Site Address:- 2 Eastoke Avenue, Hayling Island, PO11 9QW
Your Ref:- APP/20/00699

Proposed New Garage, New driveway with new entrance to number 2 which will now be in Southwood Road, not Eastoke Avenue, demolishing of existing conservatory and replacing with a new two story extension with porch on the ground floor, New second level extension to North Elevation of 2A. All of which except the new garage have not been mentioned on the proposed plan or detailed information regarding the new extensions to 2 and 2A.

Hayling Island – Proposed Block Plan

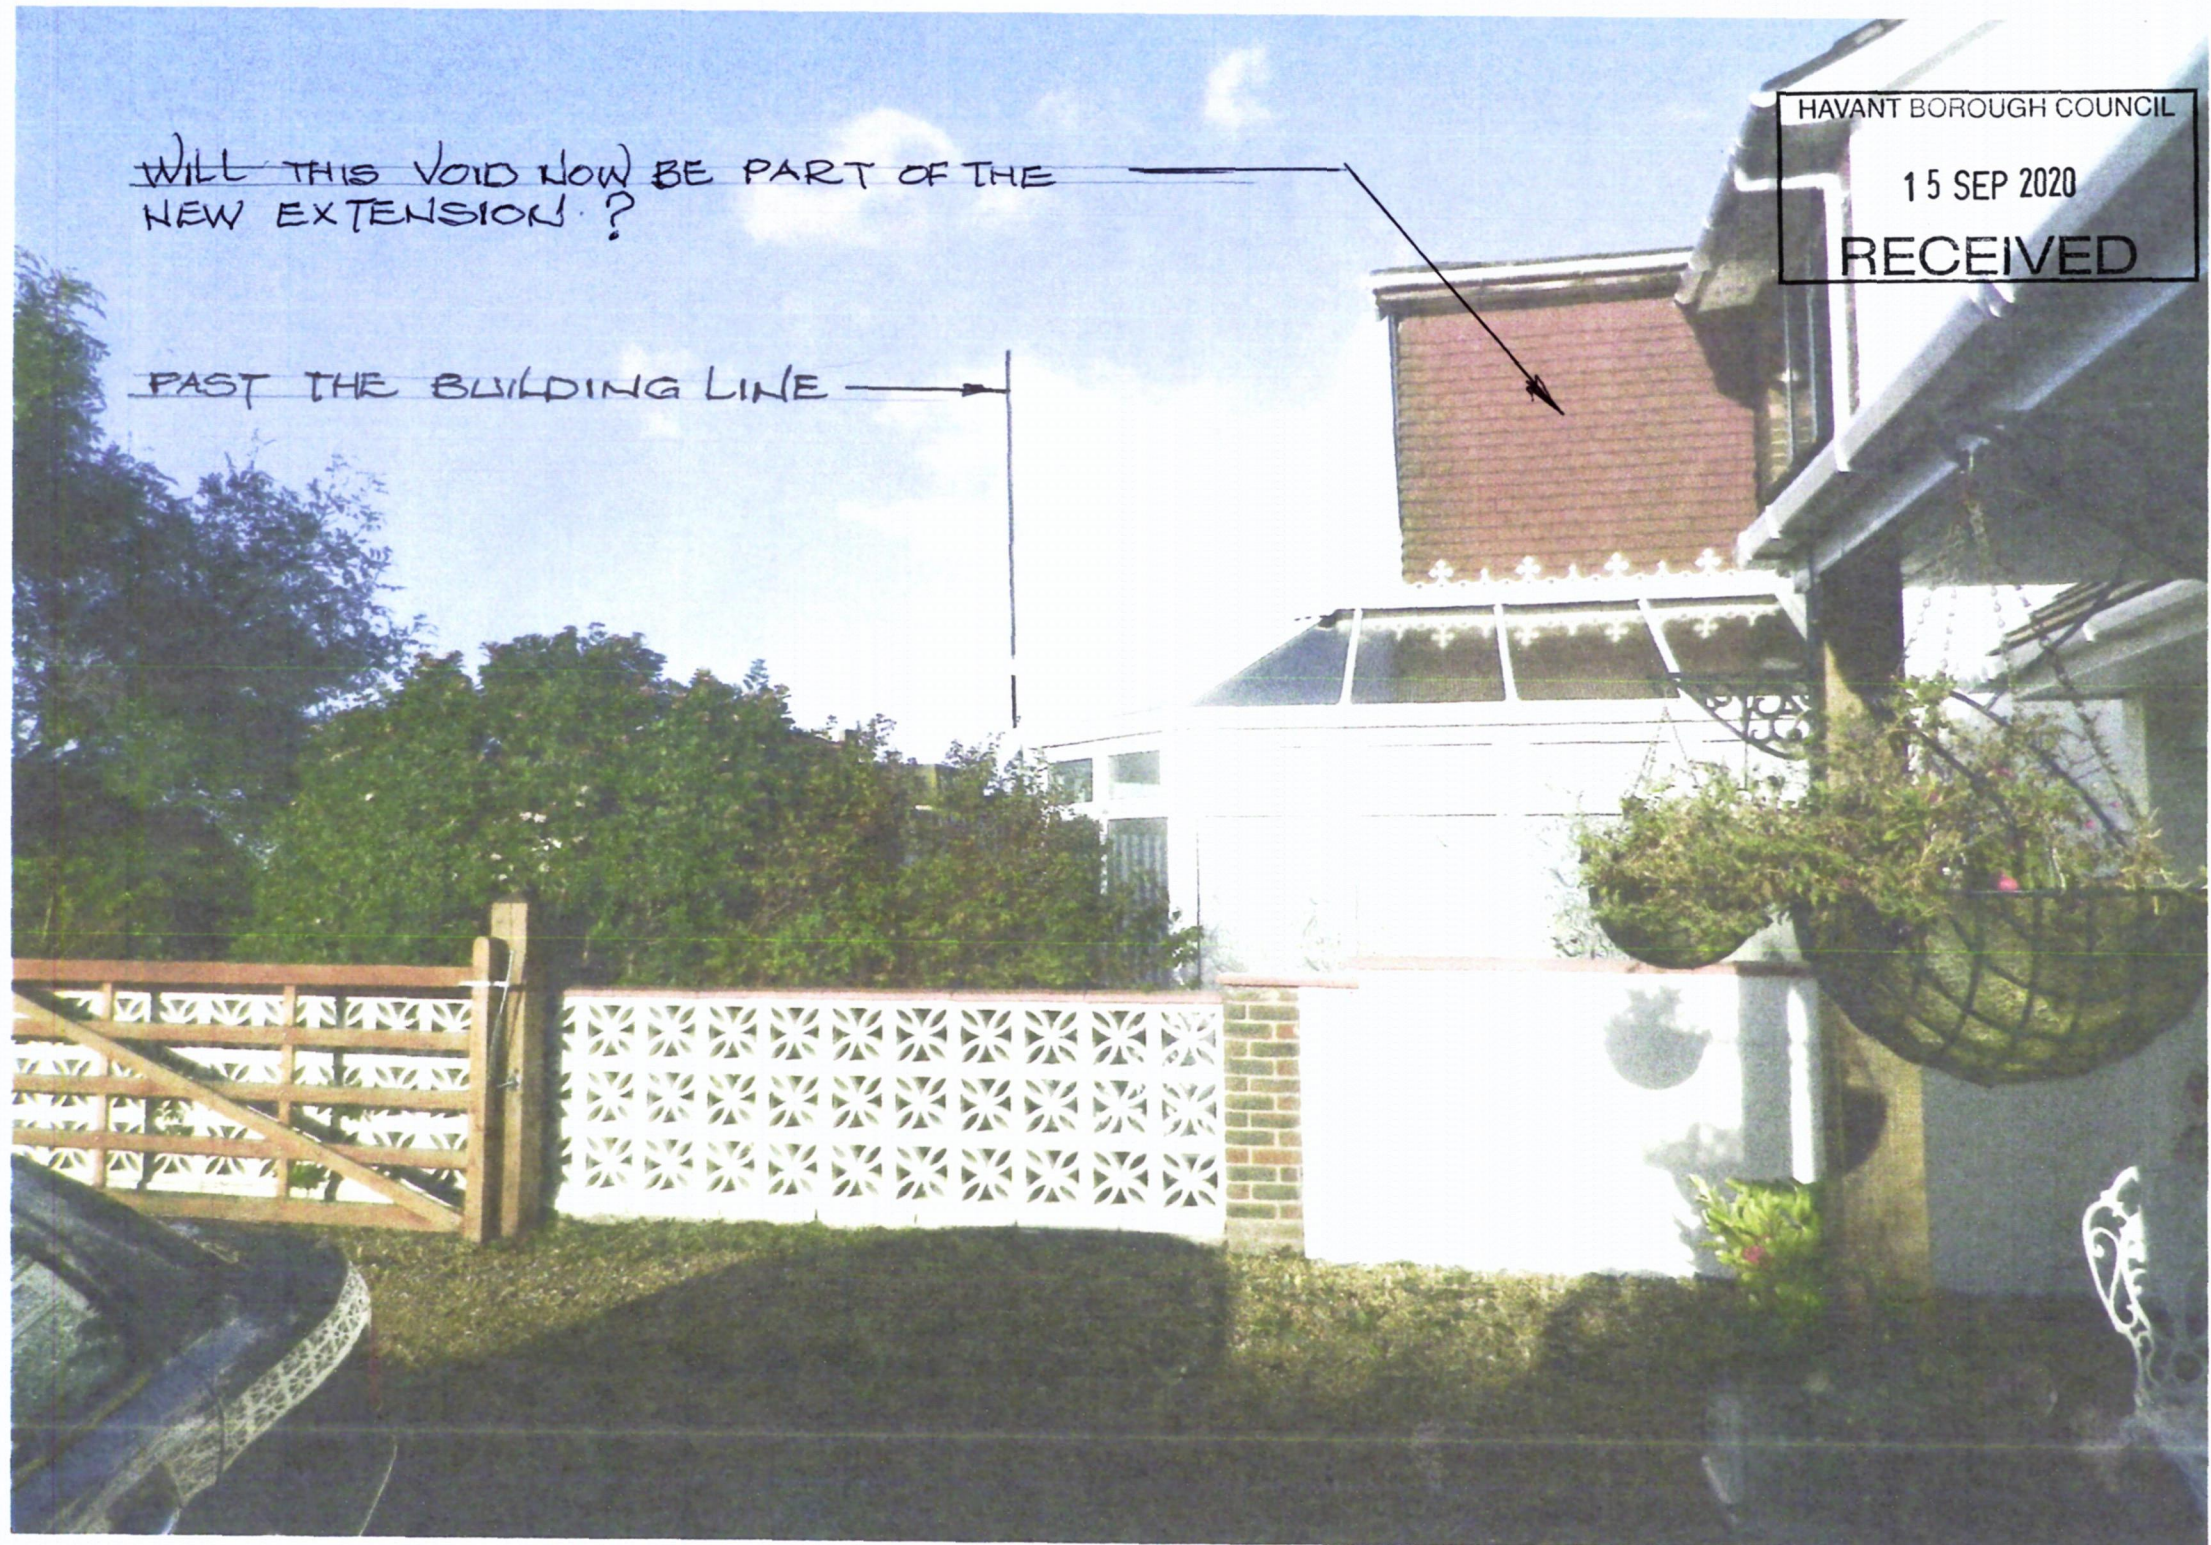
WILL THIS VOID NOW BE PART OF THE
NEW EXTENSION?

PAST THE BUILDING LINE

~~two-storey~~
SINGLE two-storey

SINGLE
two-storey

2 Eastoke Avenue, Hayling Island – Proposed Site Plan

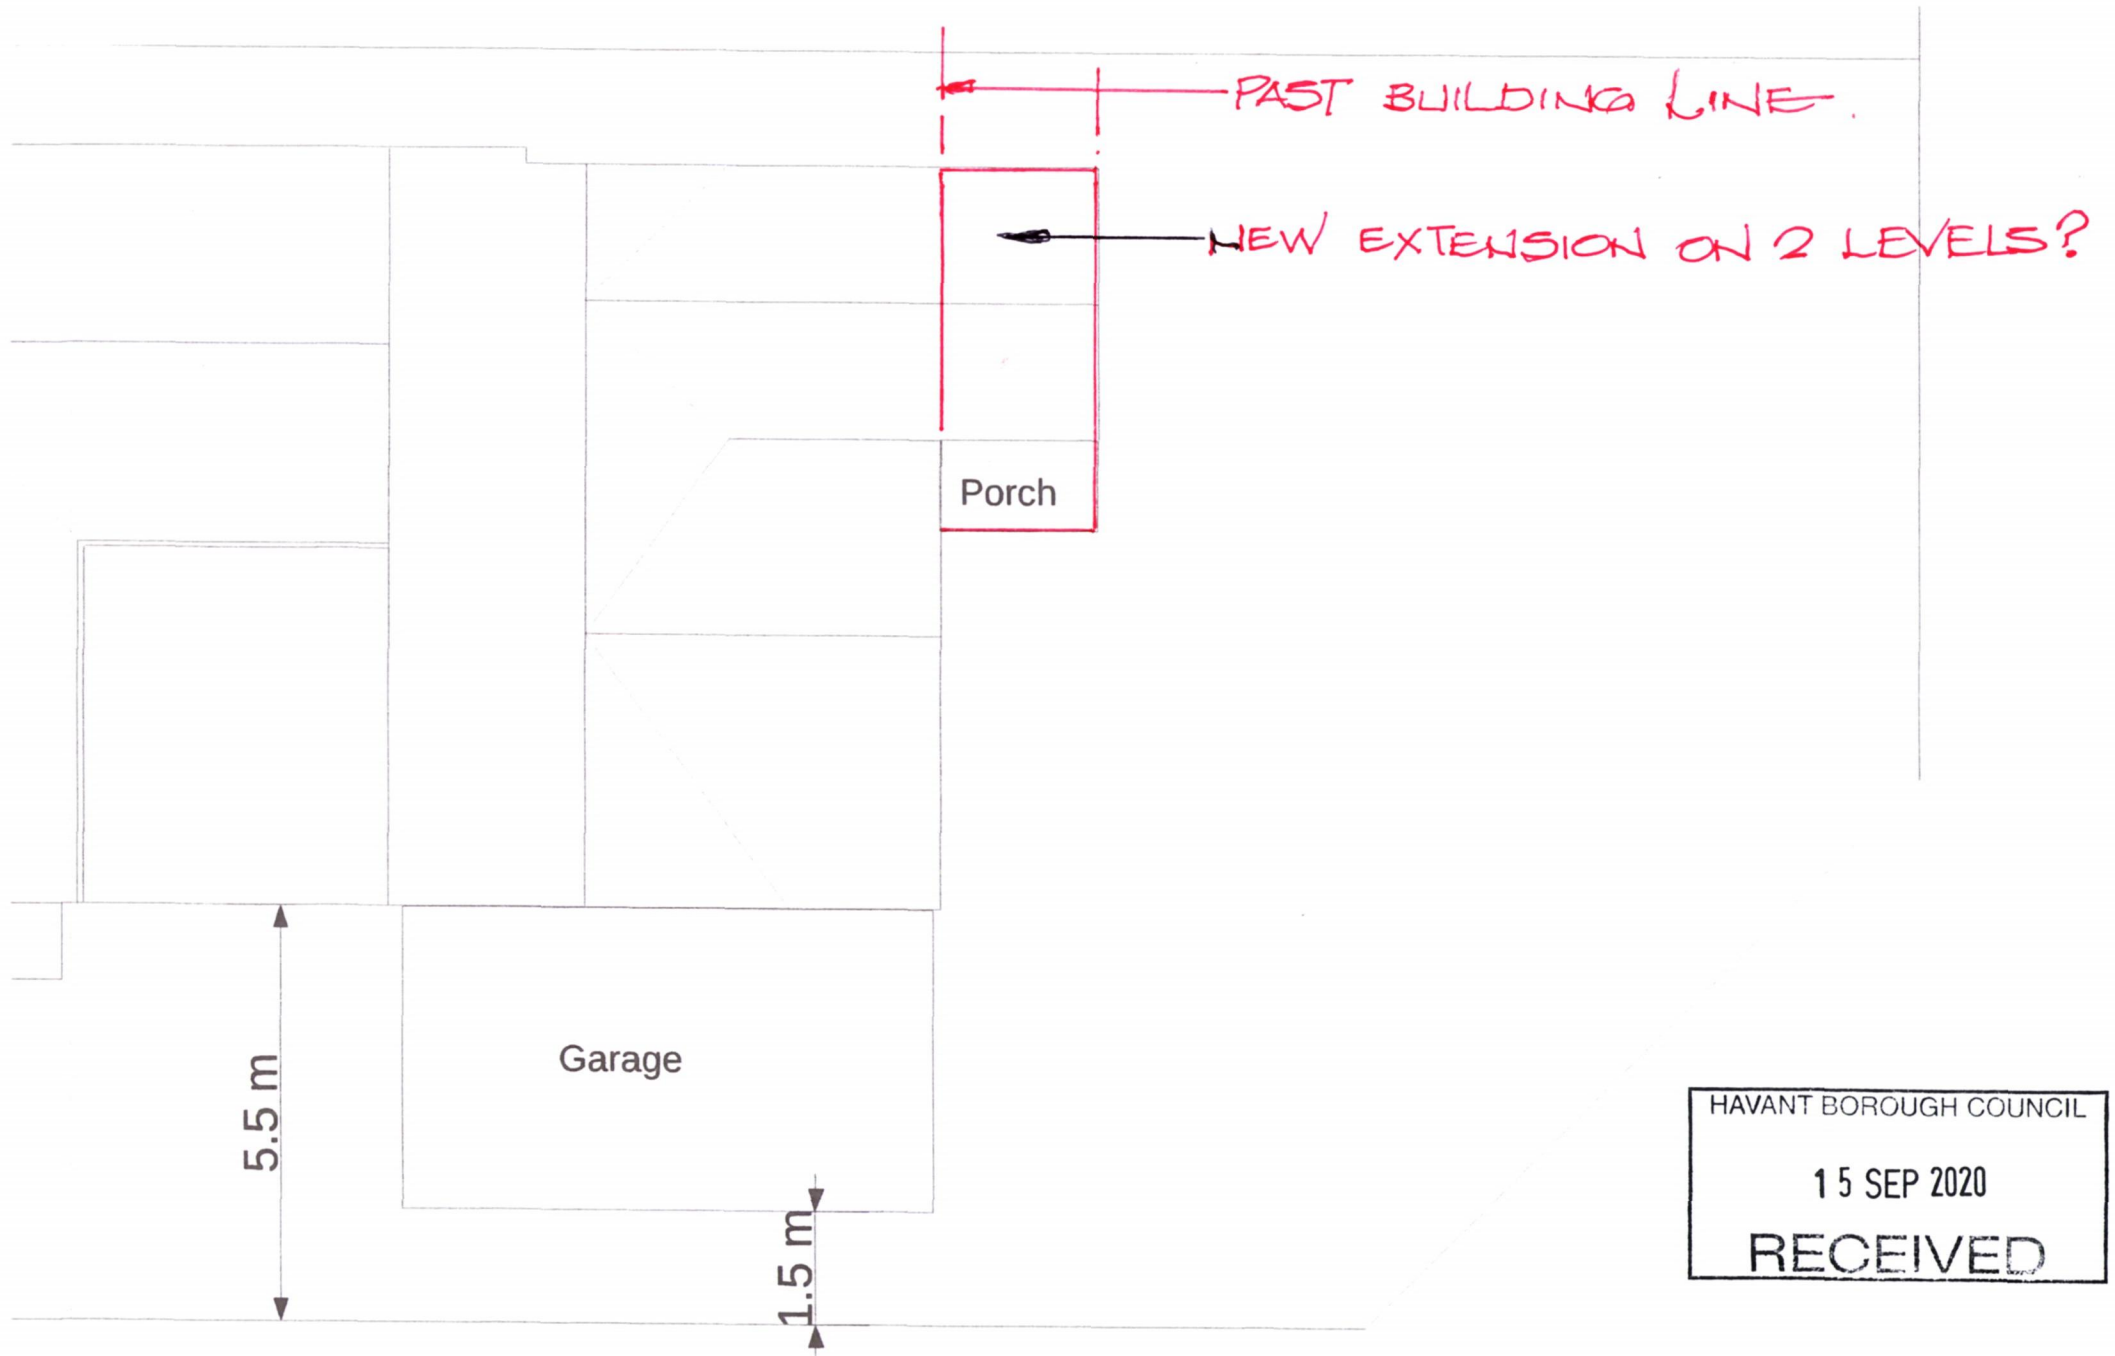
NEW EXTENSION ON ALL SIDES
LOOKING INTO 81 CONSERVATORY
& REAR PATIO & GARDEN

2 Eastoke Avenue, Hayling Island – Proposed Site Plan

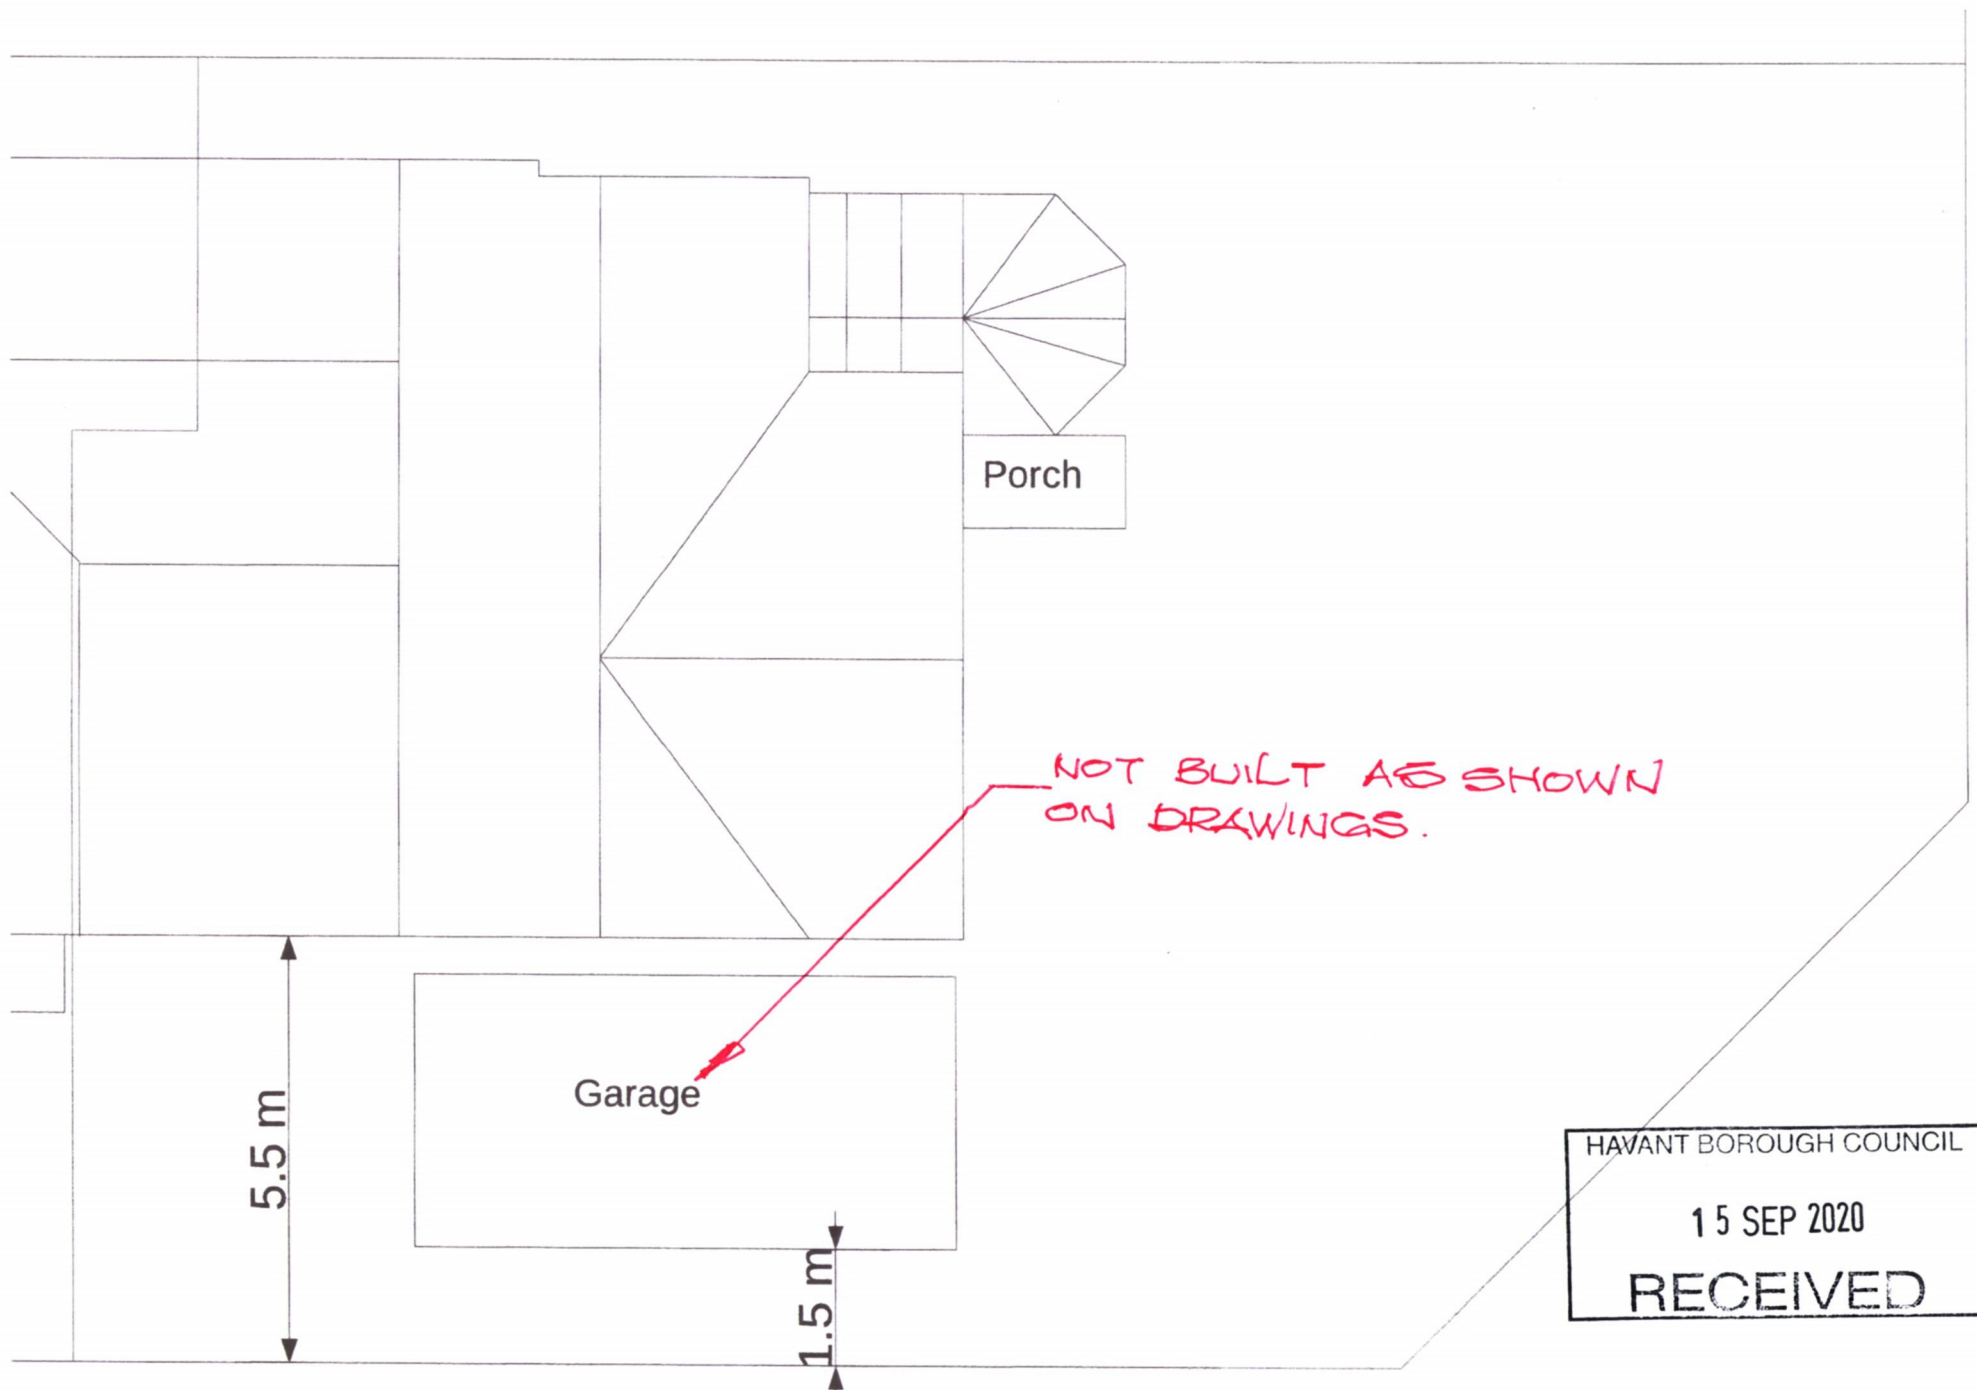
GAP BETWEEN HOUSE &
GARAGE NOT BUILT AS DRAWING
& SHOULD BE REJECTED.

1m GAP NOT
1.5 AS STATED

NOT BUILT AS SHOWN
ON DRAWINGS.

CONSERVATORY
STILL SHOWN
